# ISC-C1 Rack

Title		
ISC System Wiring Diagram		
Size	Number	Revision
B	D1900511	V11
Date:	4/21/2025	Sheet of 1 43
File:	C:\Users\...\ISC_C1_SH1.SchDoc	Drawn By: Filiberto Clara

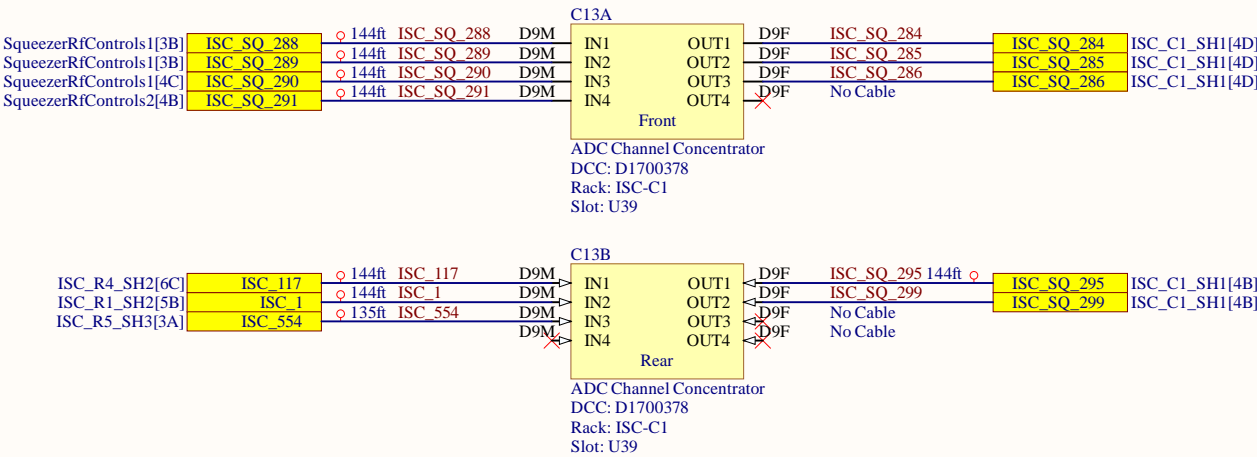
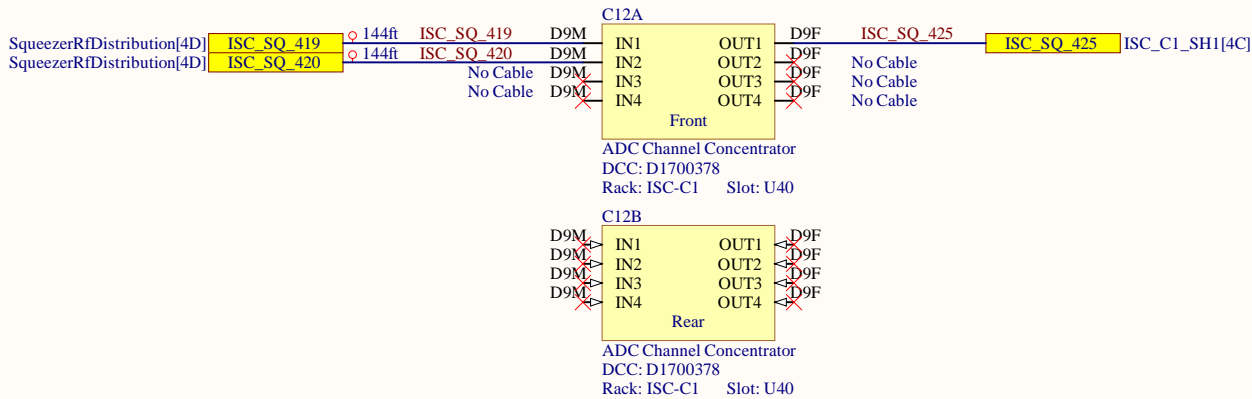
Following cables are not connected in the CER:

ISC\_101,ISC\_175,ISC\_242, ISC\_410.

# ISC-C3 Rack

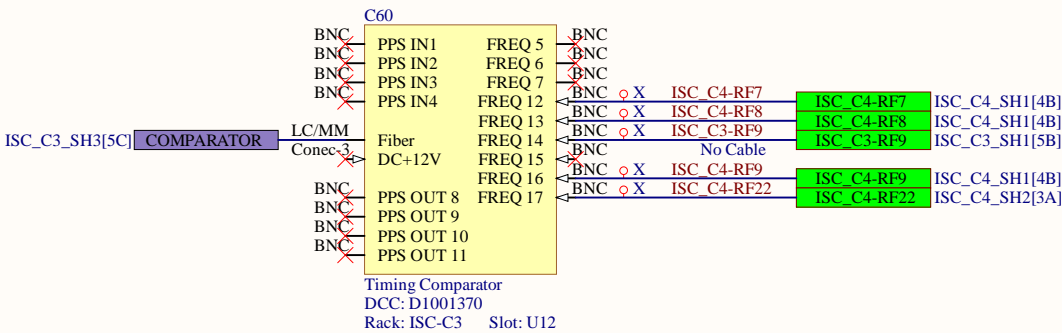
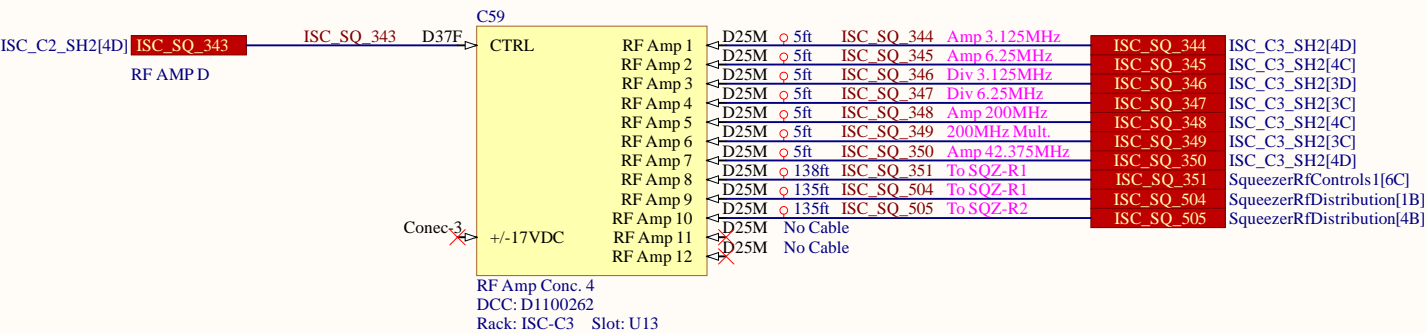
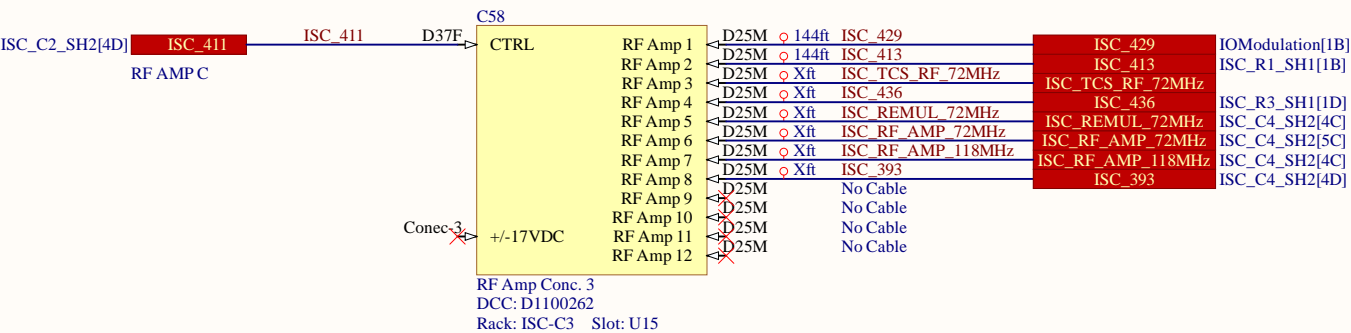
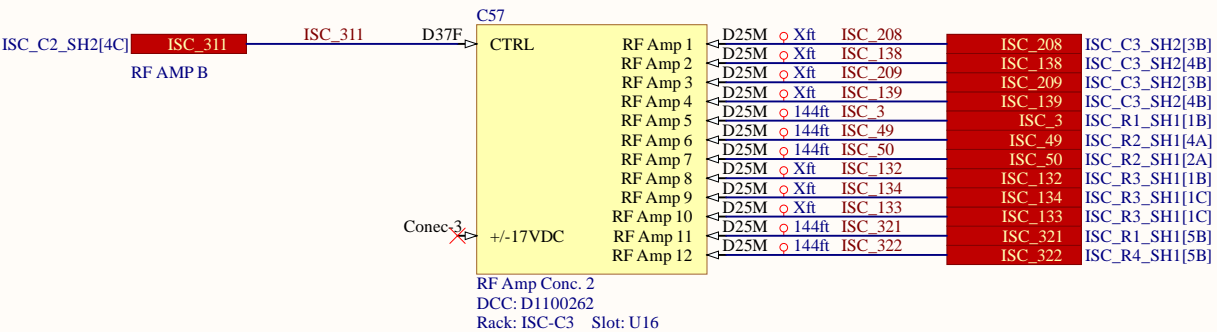
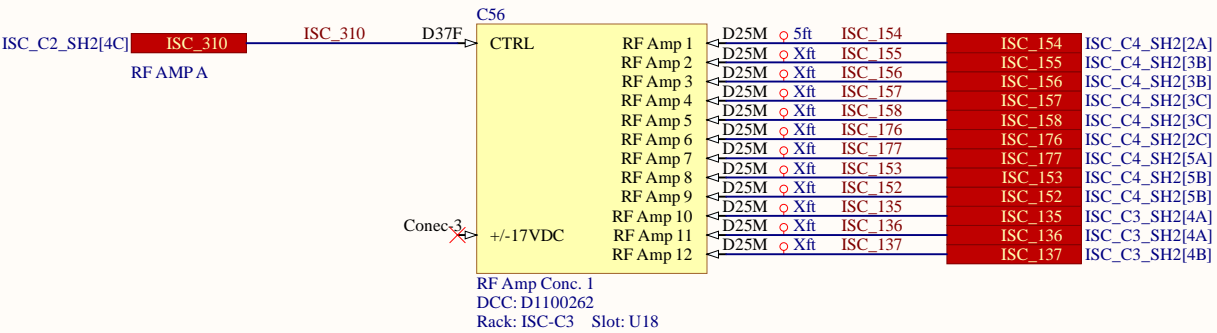
Cables that are removed  
ISC\_SQ\_31  
ISC\_SQ\_12  
ISC\_SQ\_78

# ISC-C3 Rack

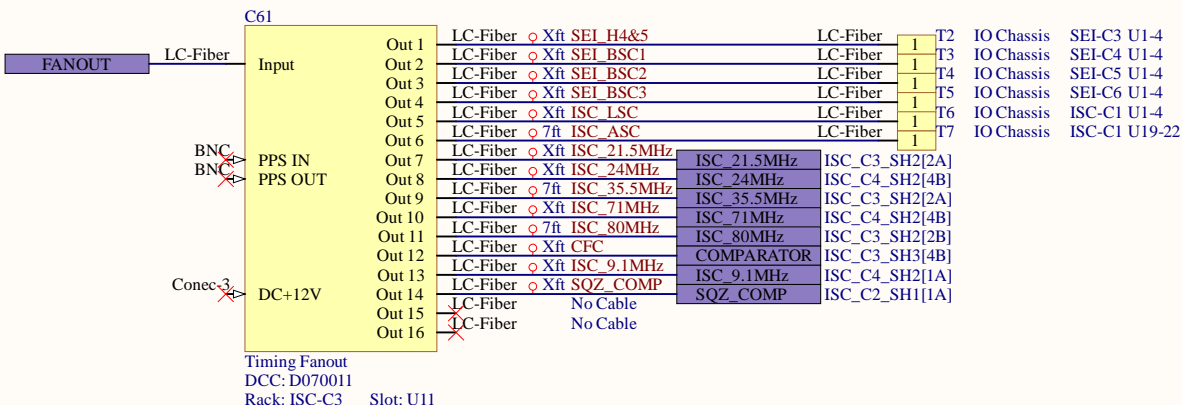
Need Locations of other ends.  
SEI IO Chassis

COMM PLL

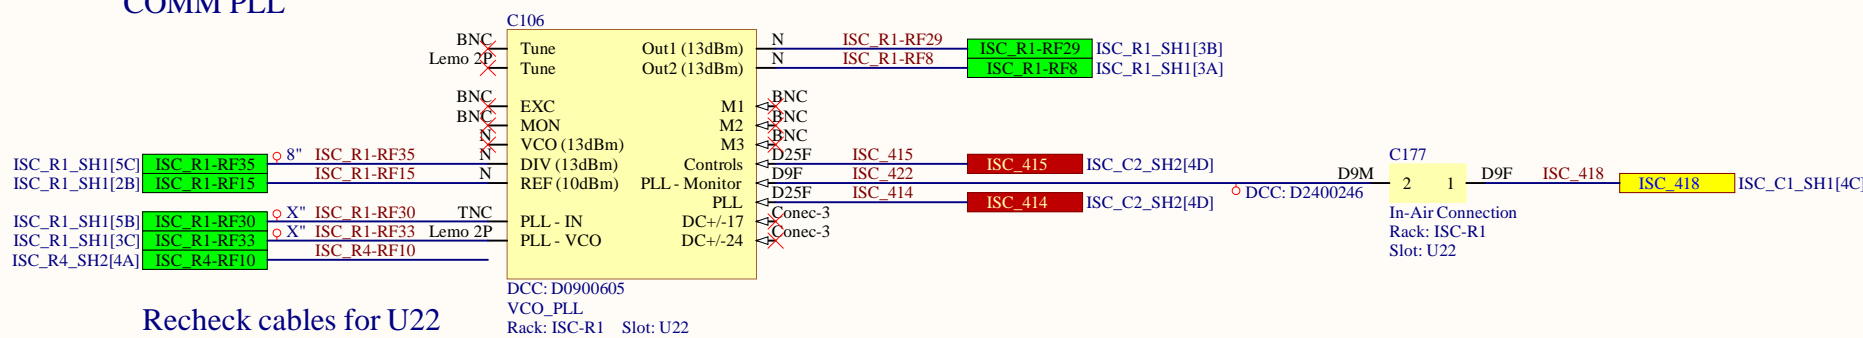
Recheck cables for U22  
In back for PLL

# ISC-R1 Rack

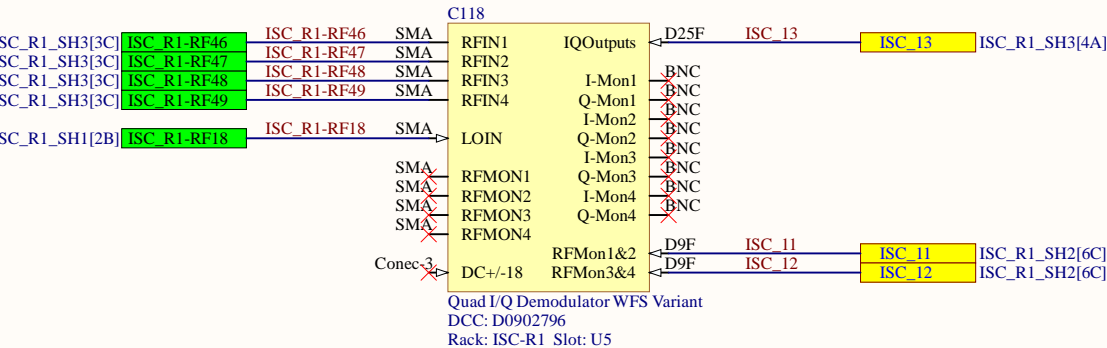
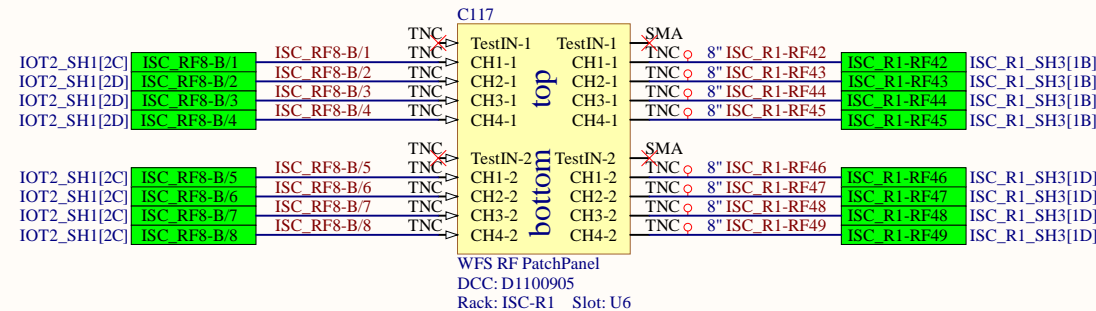
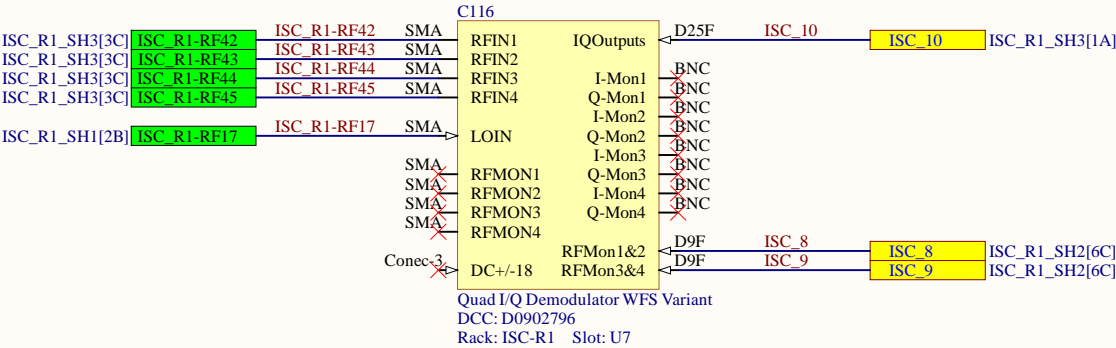
Need to locate other end

434/435 already used  
ASC-POP\_X\_PIT/YAW

Title		
Squeezer RF Distribution		
Size	Number	Revision
C	D1900511	V11
Date:	4/21/2025	Sheet of 37 43
File:	C:\Users\...\SqueezerRfDistribution.SchDpDrawn By: R. Abbott

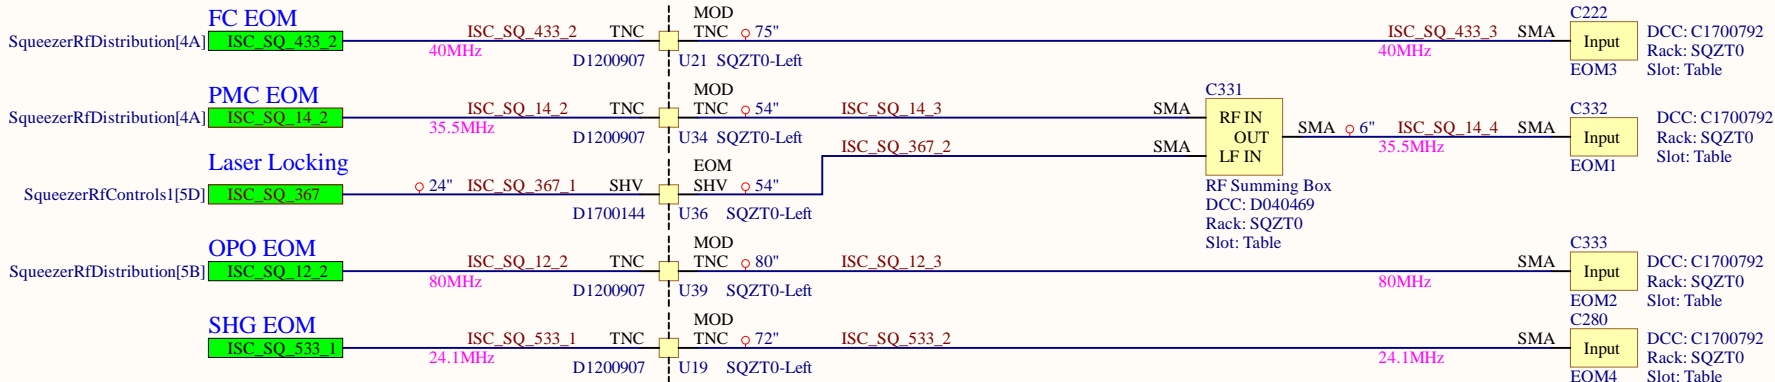
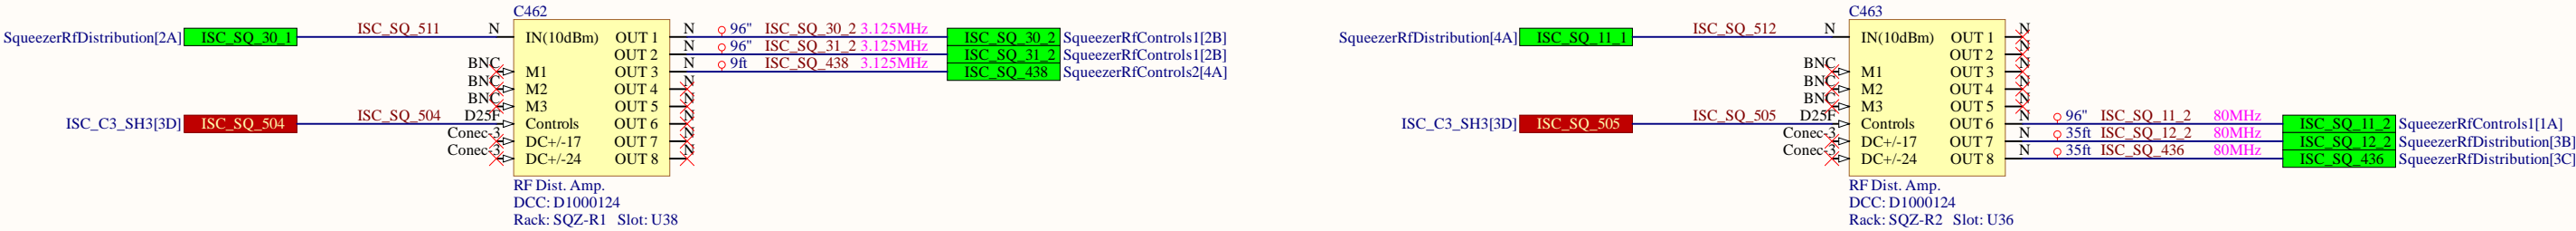
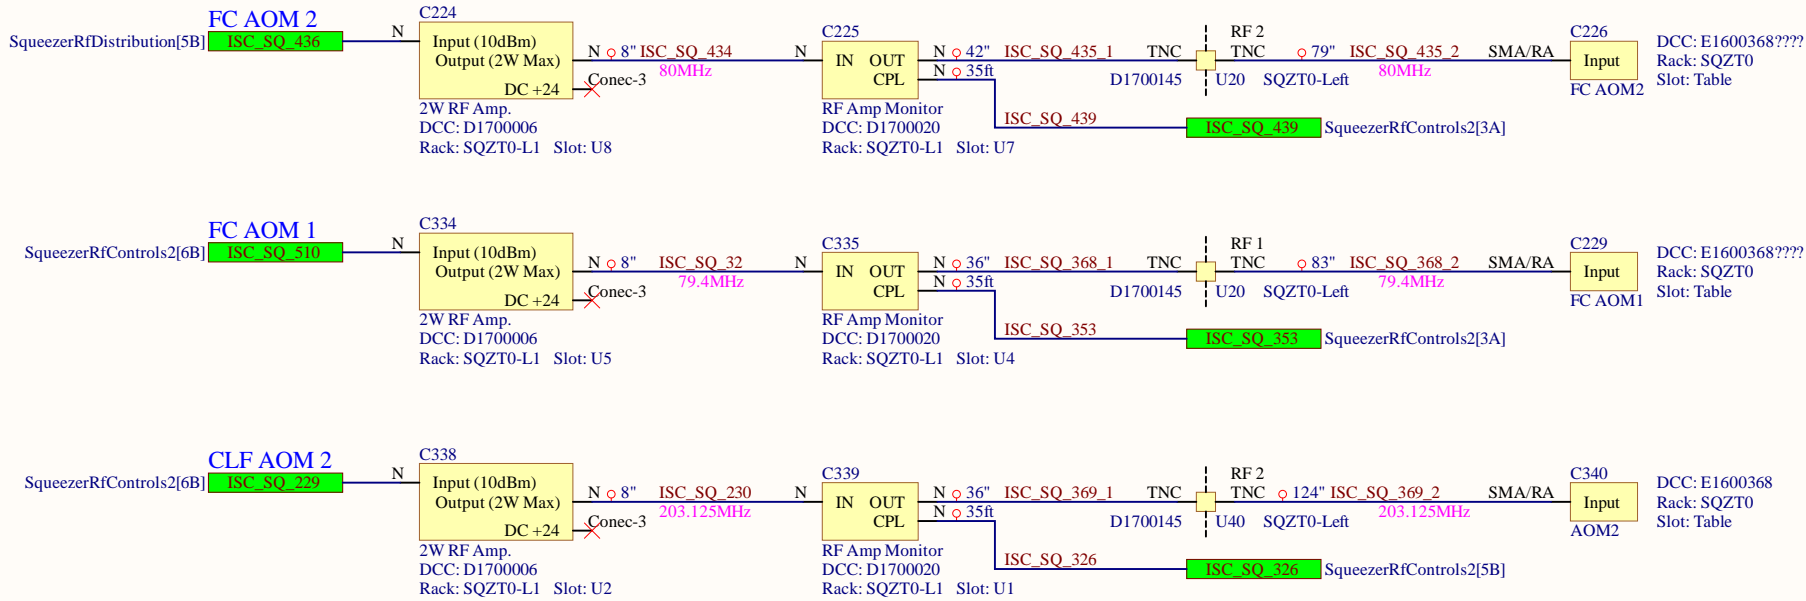
New cables for A\_ start at ISC\_SQ\_430

Part Number??

RF cables carrying the AOM signals need to be 1/4" superflexible helical corrugated coax.
